DRAWING LIST

DA SUBMISSION

PROPOSED MIXED USE DEVELOPMENT

684-700 CANTERBURY ROAD BELMORE

ROOF PLAN

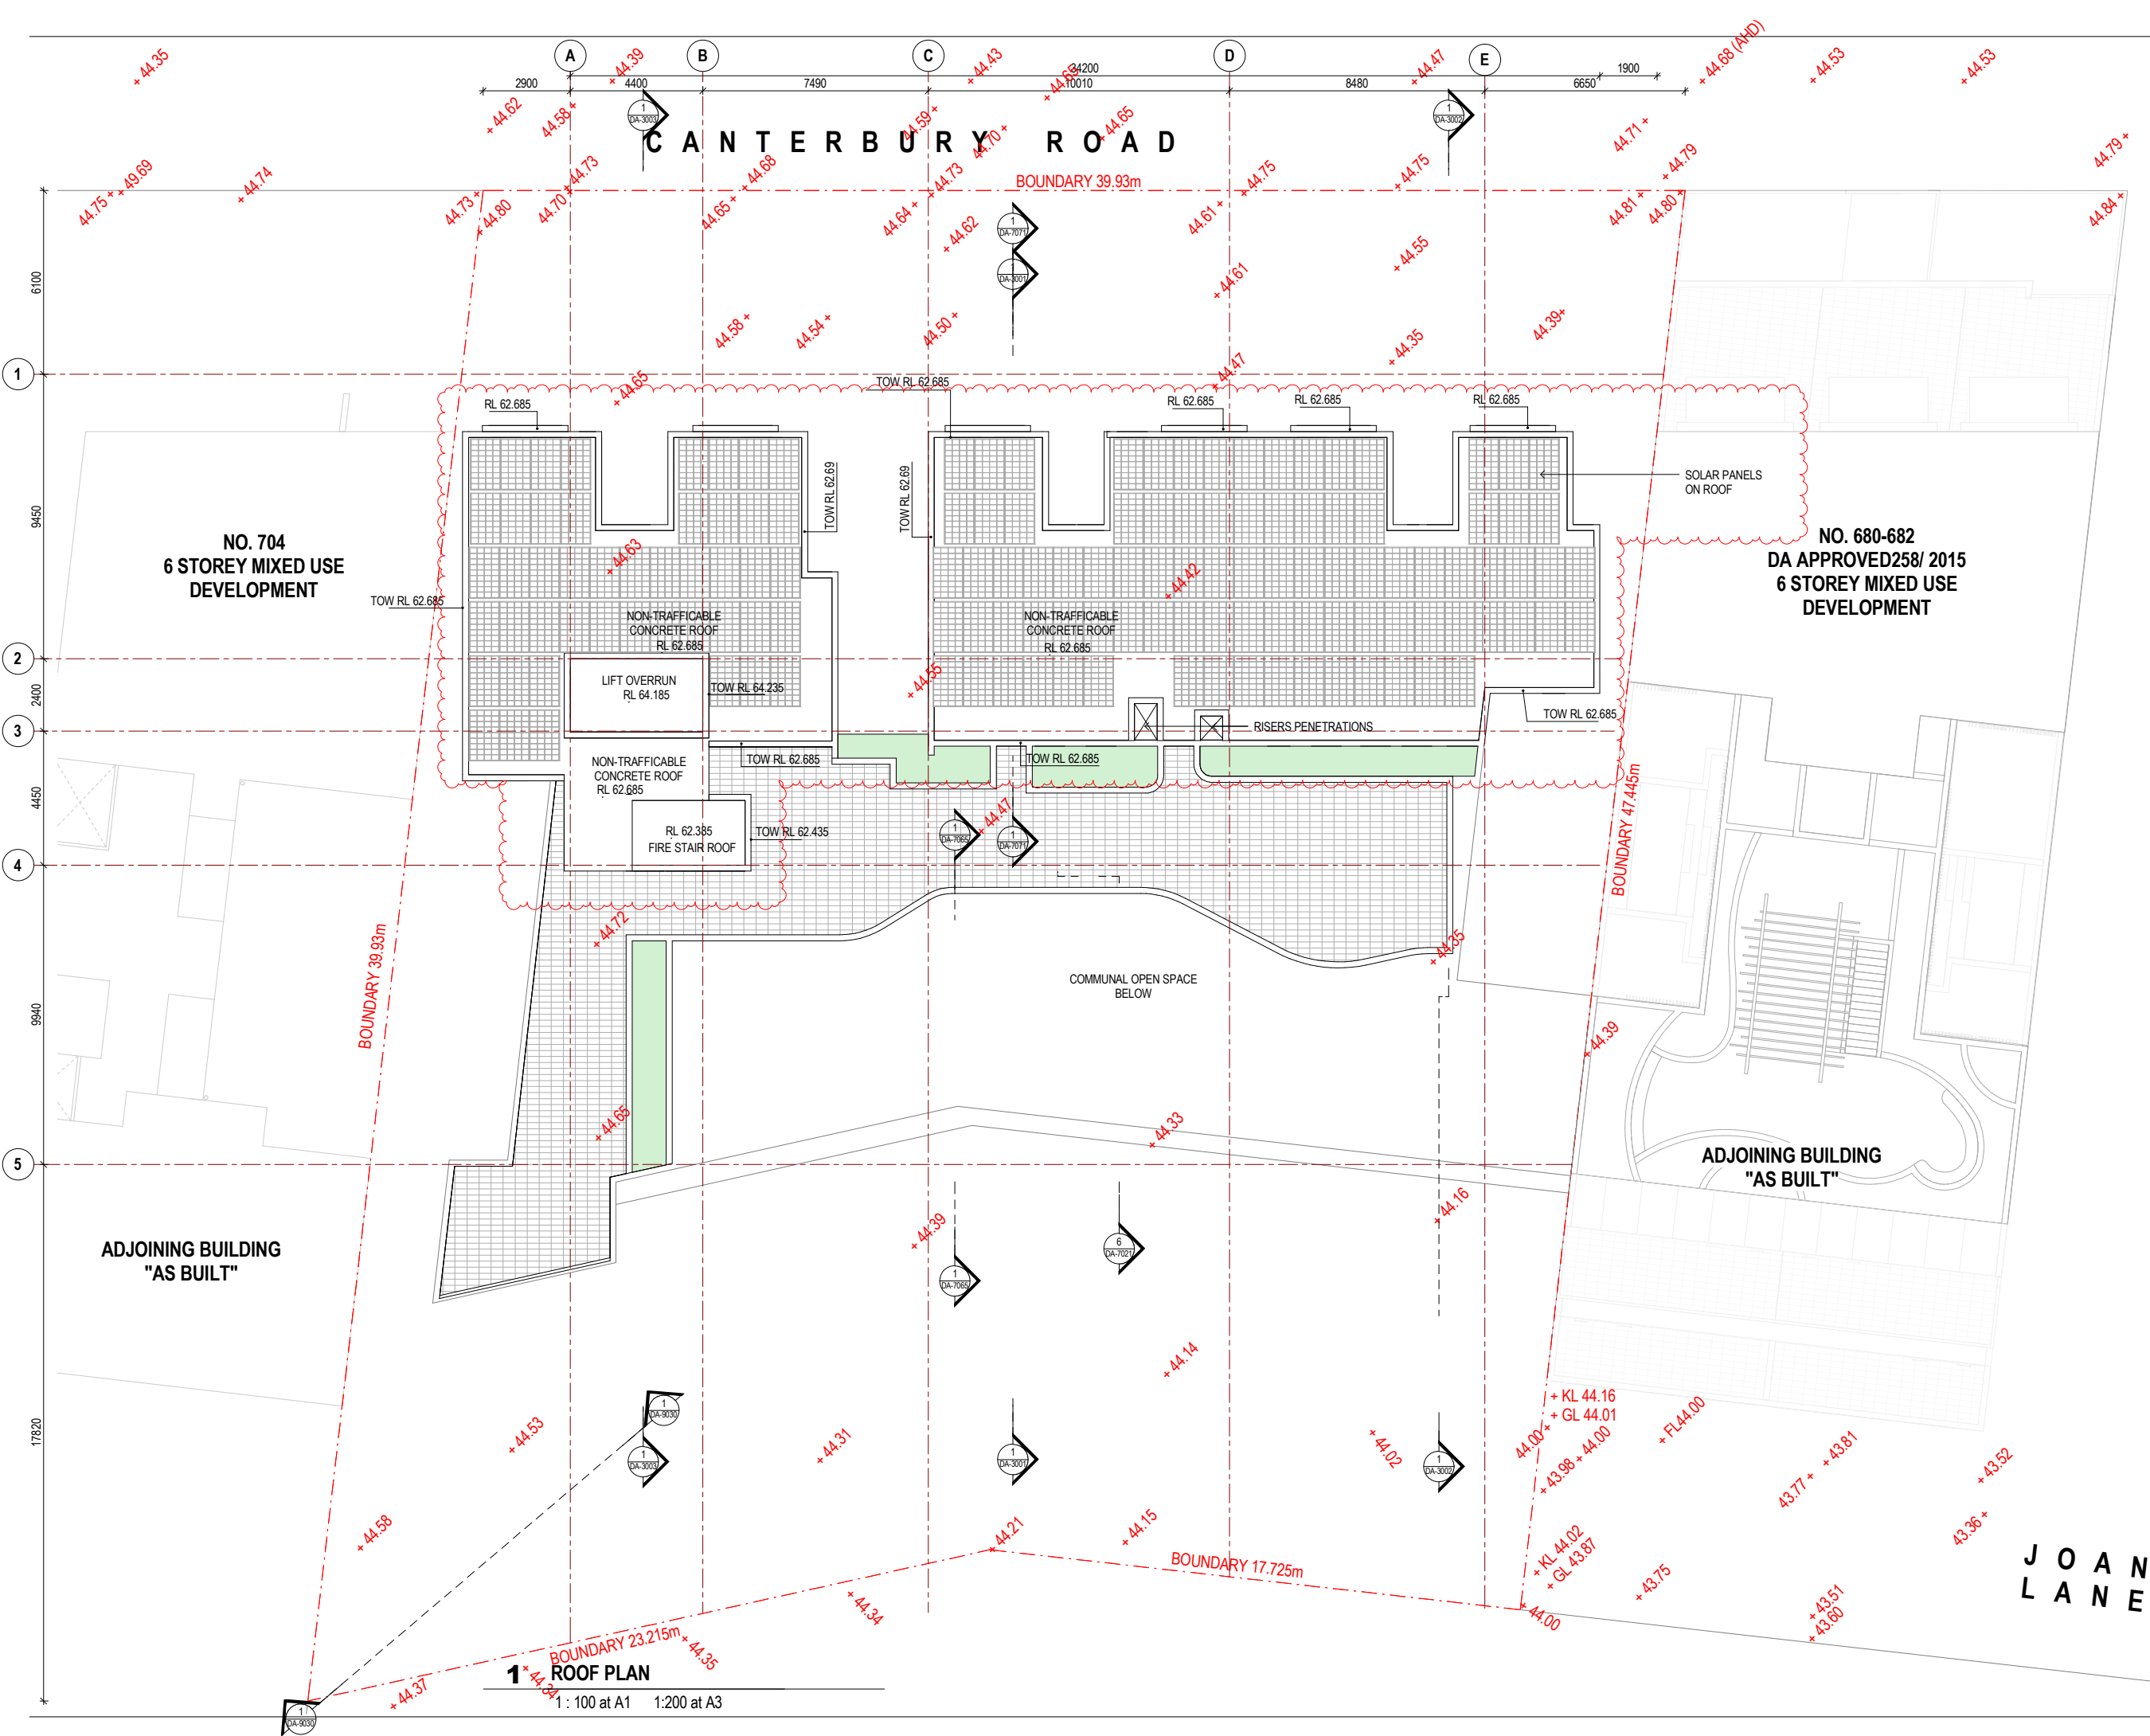
List of Changes: 23.05.22

- Firestair & Lift Core extended to roof level
- Solar Panels added to roof top

1 NORTH ELEVATION

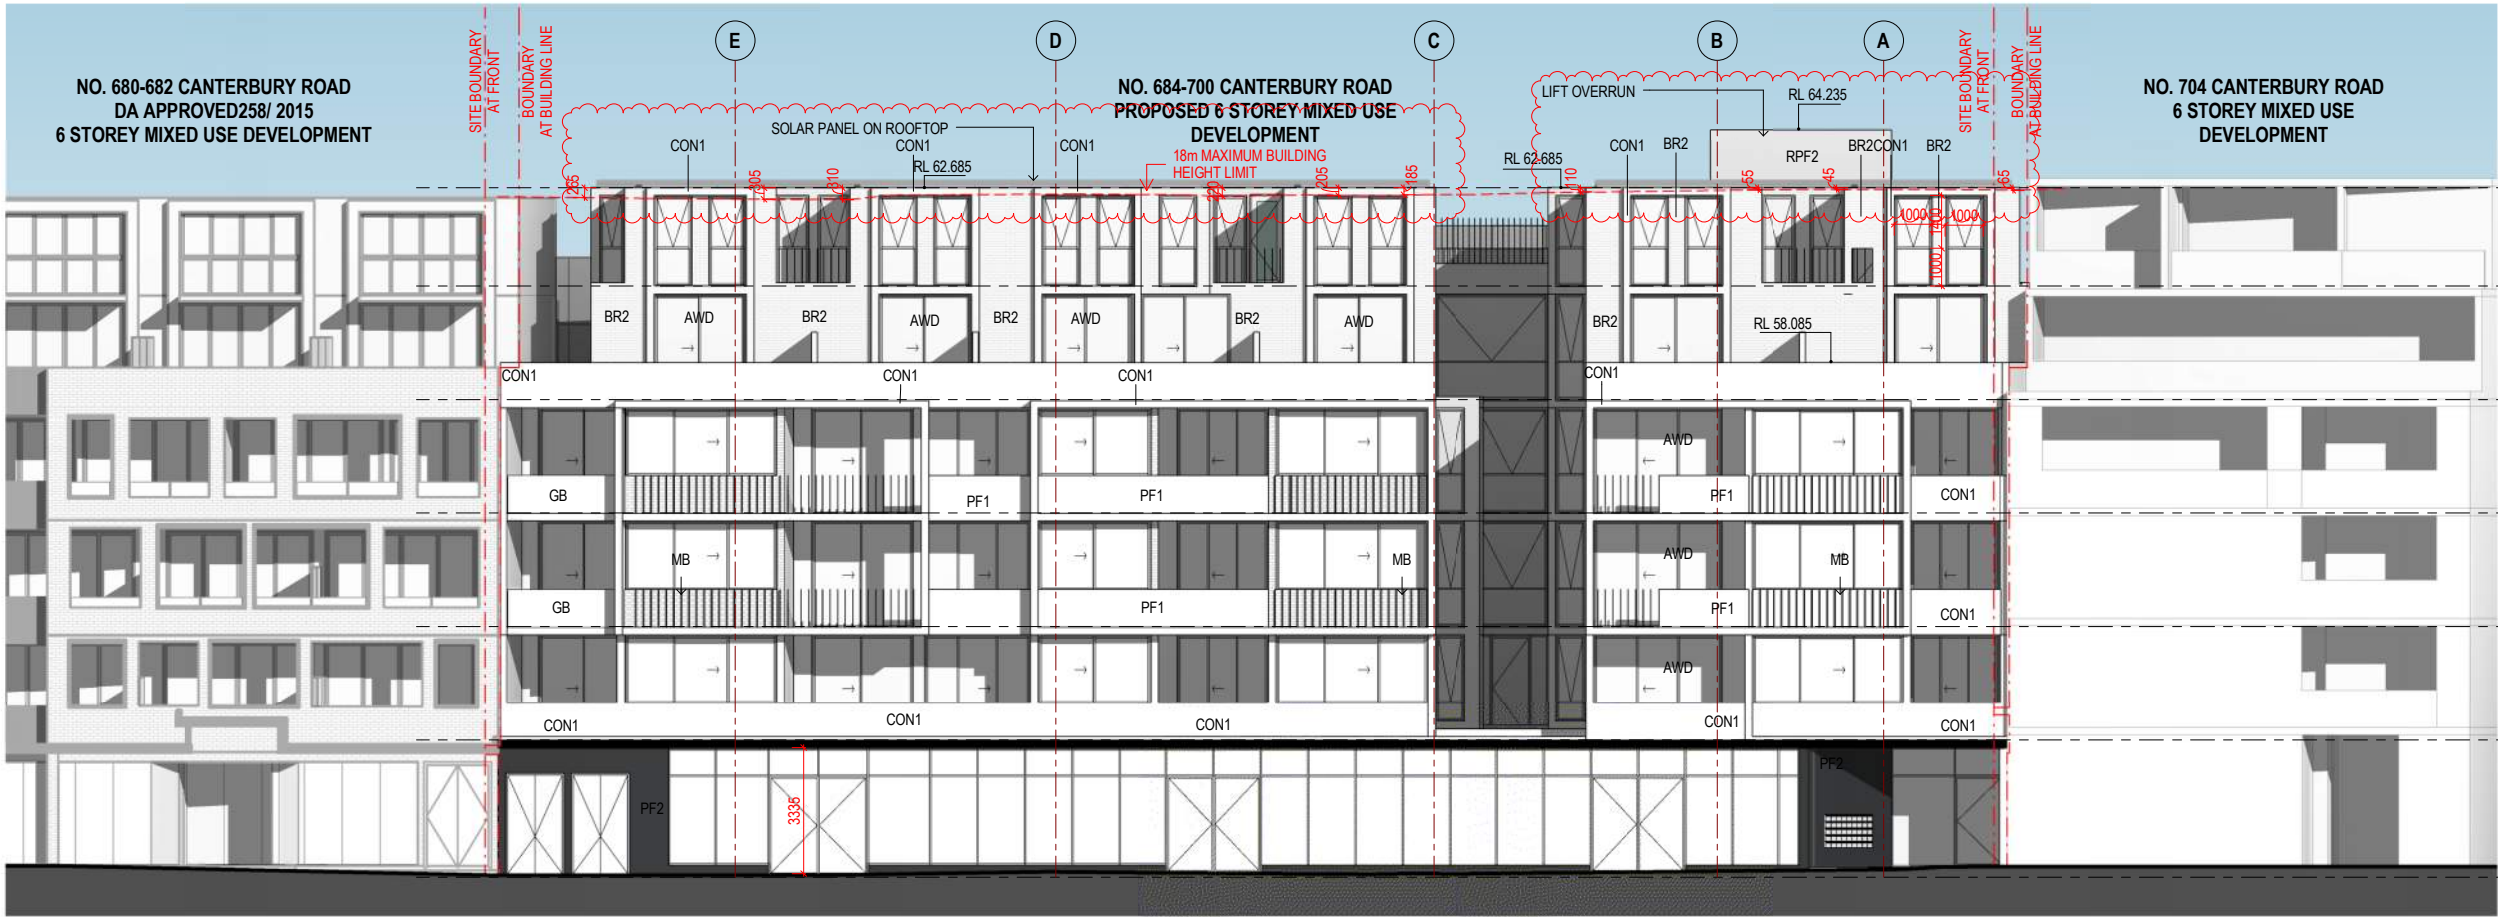
List of Changes: 23.05.22

- Firestair & Lift Core extended to roof level
- Solar panels added on rooftop

1 SOUTH ELEVATION

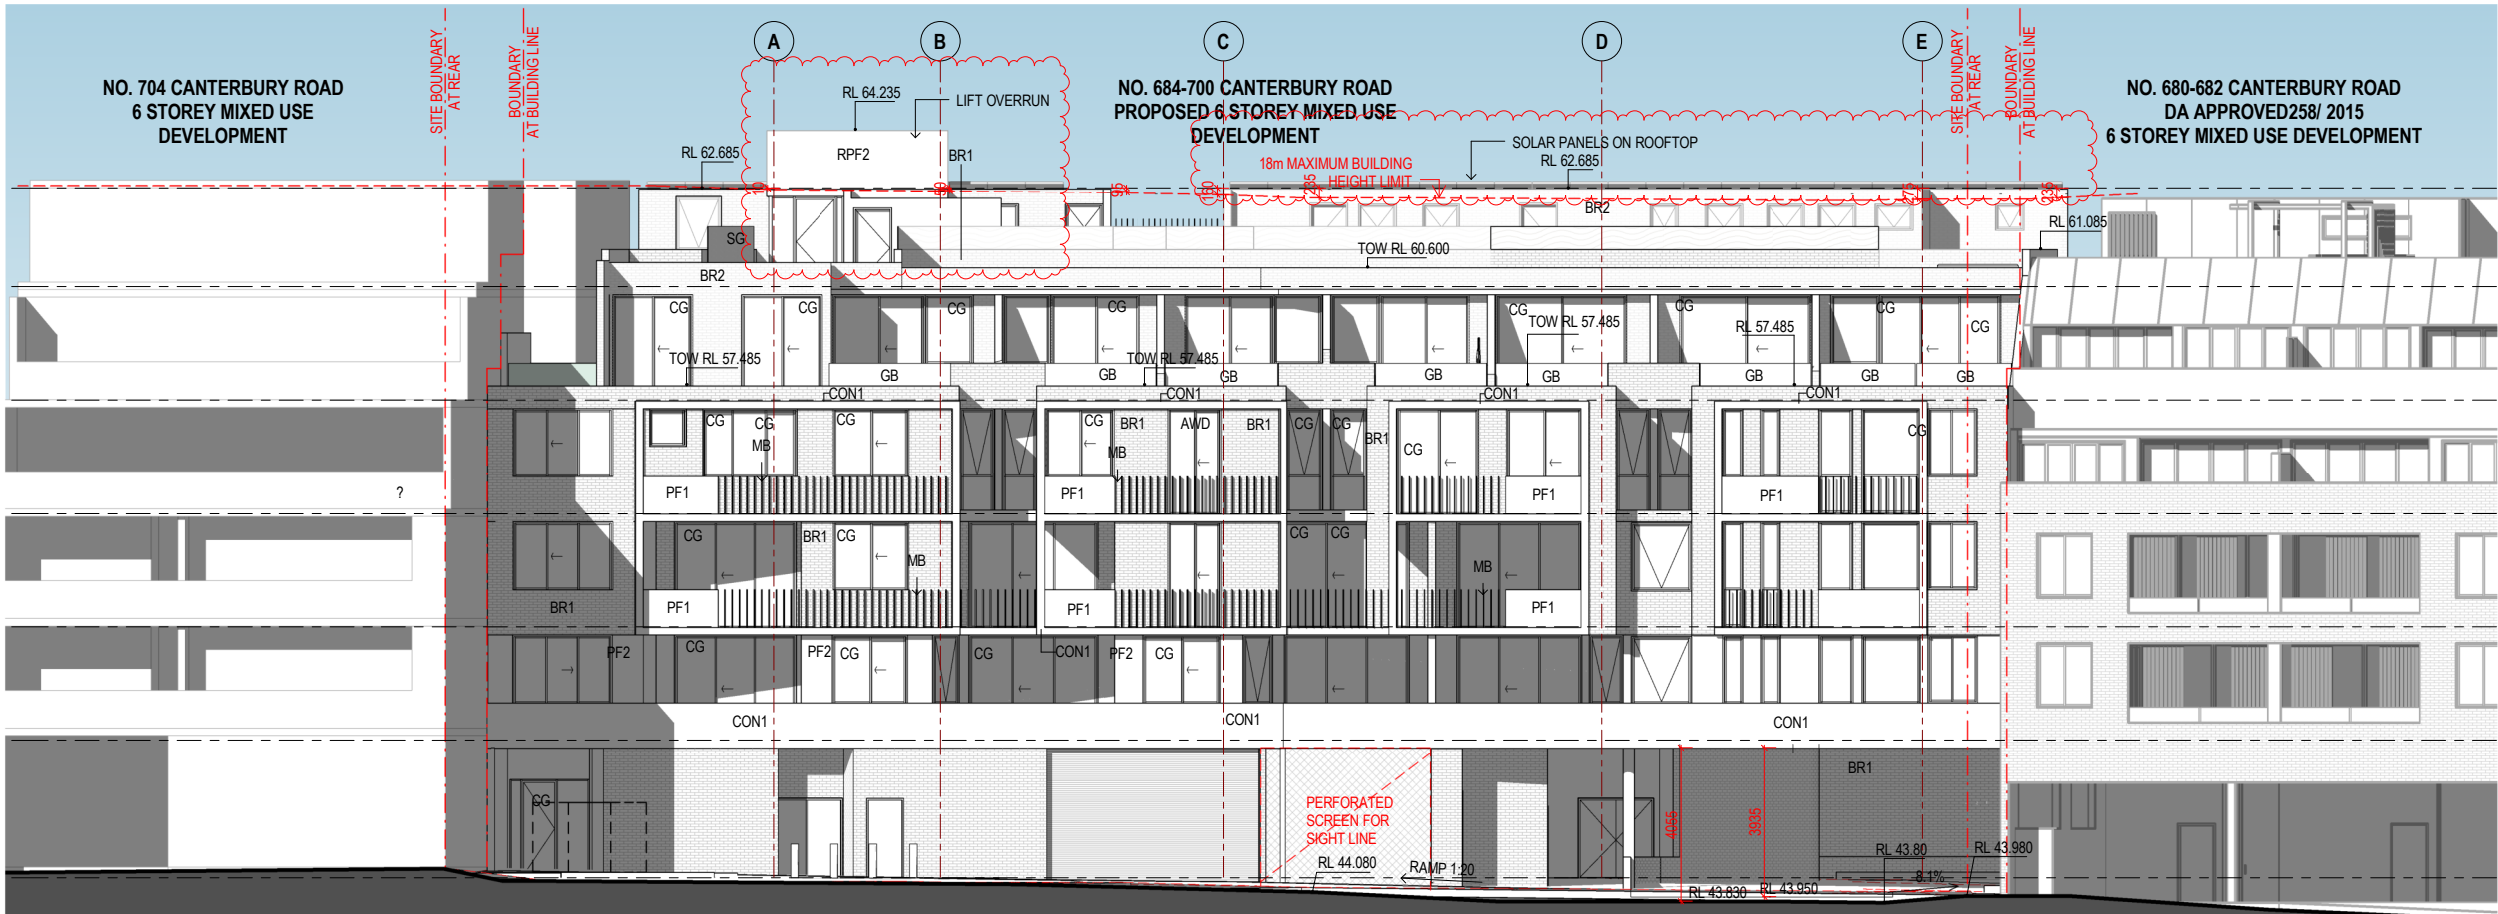
List of Changes: 23.05.22
• Firestair & Lift Core extended to roof level
• Solar panels added on rooftop

1 EAST ELEVATION
1 : 100 at A1 1:200 at A3

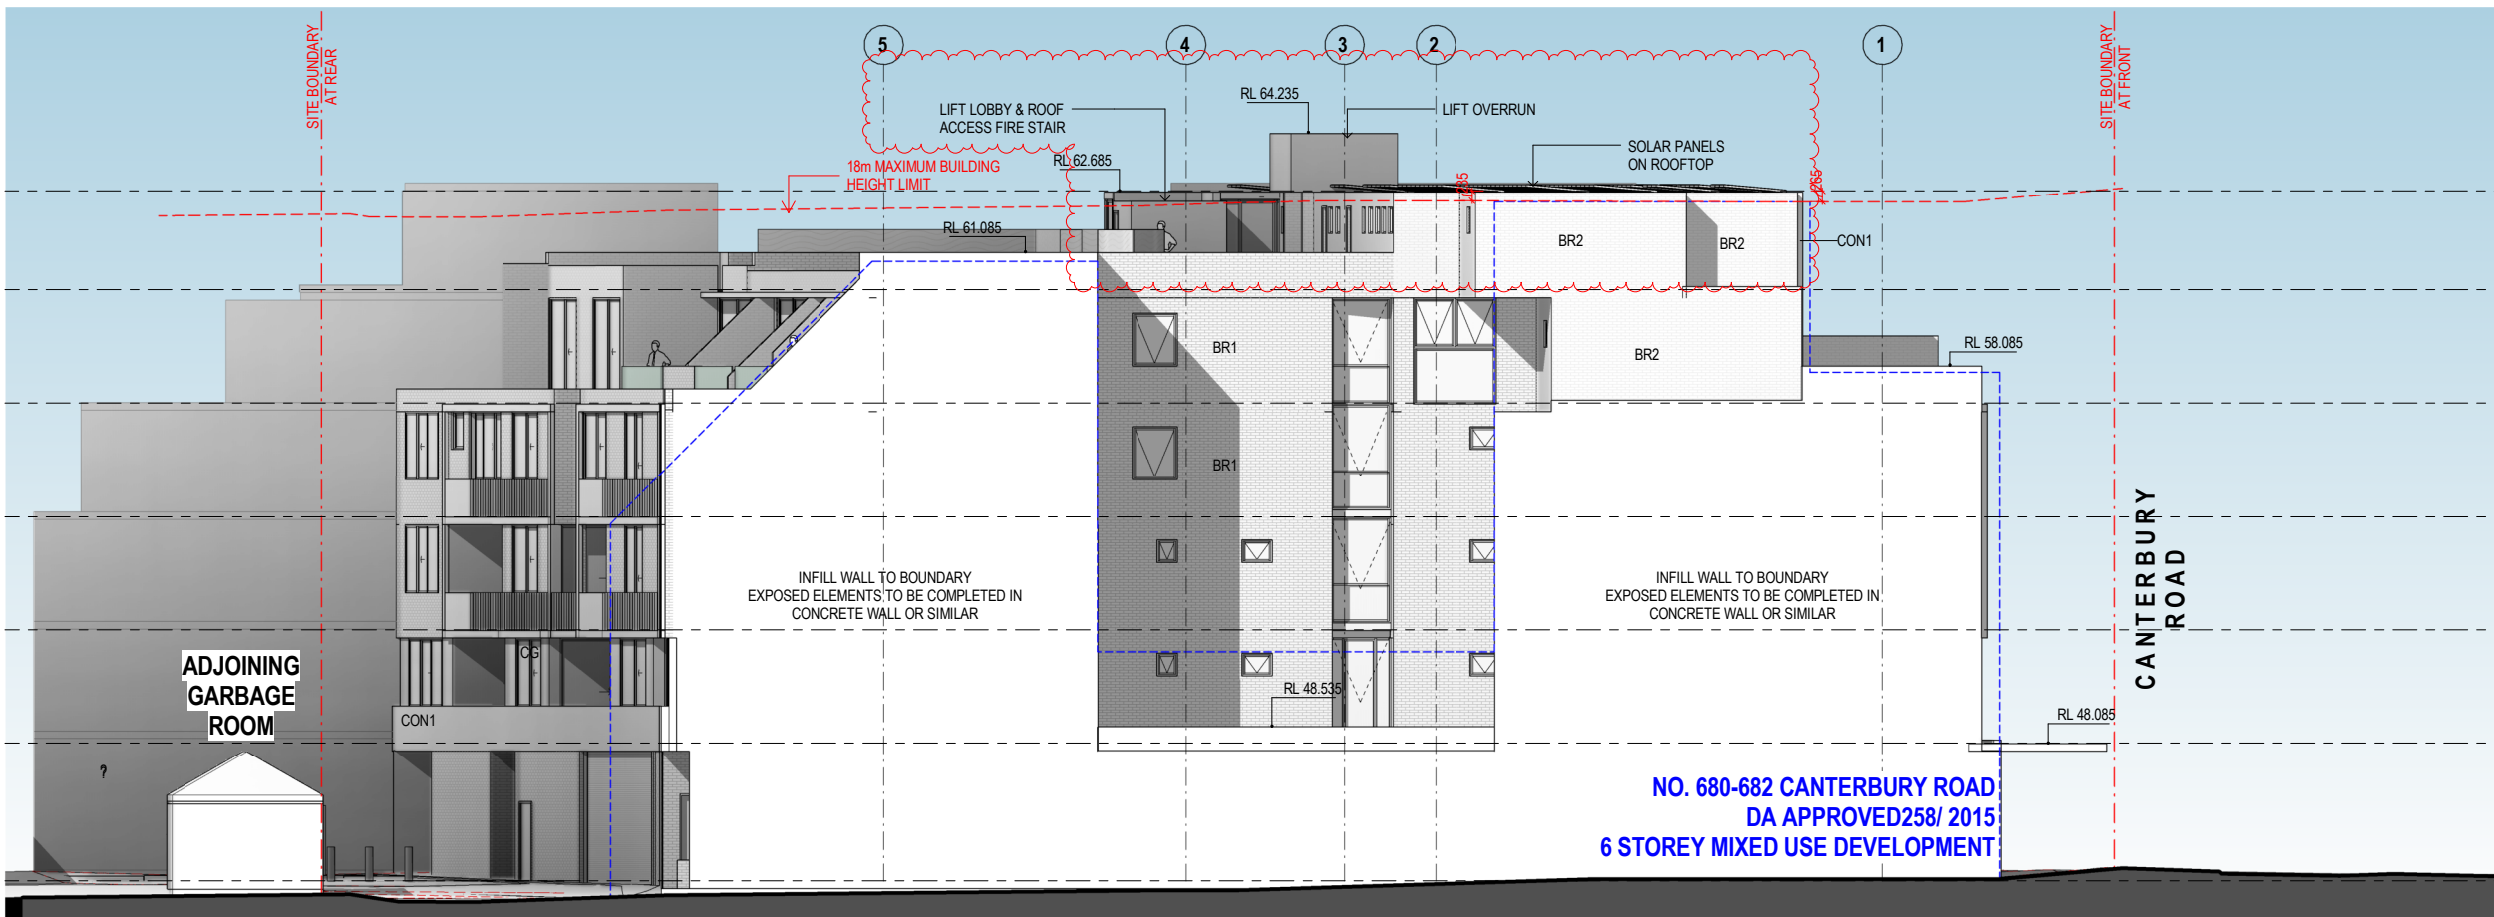
List of Changes: 23.05.22
• Firestair & Lift Core extended to roof level
• Solar panels added on rooftop
